Access Compliance Report

Public Rights-of-Way

(Curb Ramps)

Intersection ID: 47283	Main Street: REIDHAVEN_ST	Cross Street: NETTLETON_CT	Location: SW
ADA ID: 616662B67D70	Ramp Type: Perp	Initial Pass/Fail: Fail	Overall Compliance: No
Severity Score: 10			
Codes/Mitigation Info/Possible Solution		Field Measurements/Component Compliance

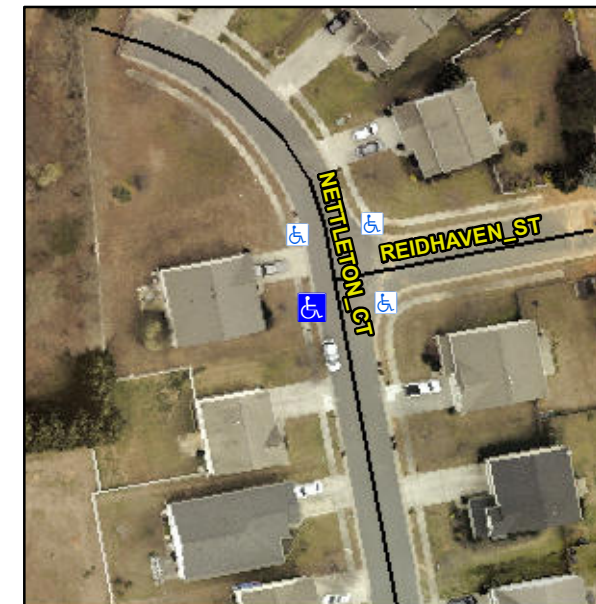
Not Found, R304.5.1, R304.5.3

Compliance	Description	Data	Compliance	Description	Data
N/A	Ramp Length (in)	47.5	Yes	Ramp Slope (%)	7.8
No	Ramp Width (in)	39.5	No	Ramp XSlope (%)	2.7
N/A	Flare Type LT	N/A	N/A	Flare Type RT	N/A
N/A	Flare Slope LT (%)	N/A	N/A	Flare Slope RT (%)	N/A
N/A	Flare Traversable LT?	N/A	N/A	Flare Traversable RT?	N/A
N/A	Landing Length (in)	N/A	N/A	DWS Provided?	N/A
N/A	Landing Width (in)	N/A	N/A	DWS Contrast?	N/A
N/A	Landing Slope (%)	N/A	N/A	DWS Length (in)	N/A
N/A	Landing X Slope (%)	N/A	N/A	DWS Full Width?	N/A
N/A	Landing Curb? (Y/N)	N/A	N/A	DWS Offset (in)	N/A
N/A	Shared Landing?	N/A			
N/A	Gutter Ponding?	N/A	N/A	Gutter Slope (%)	N/A
N/A	Gutter Lip Ht (in)	N/A	N/A	Gutter X Slope (%)	N/A
N/A	Painted X Walk1?	No	N/A	Painted X Walk2?	N/A
	X Walk 1 Direction	To E		X Walk 2 Direction	N/A
N/A	X Walk 1 Width (in)	N/A	N/A	X Walk 2 Width (in)	N/A
	X Walk 1 Slope (%)	3.6		X Walk 2 Slope (%)	N/A
	X Walk 1 X Slope (%)	1.8		X Walk 2 X Slope (%)	N/A

Remove & Replace Entire Ramp.
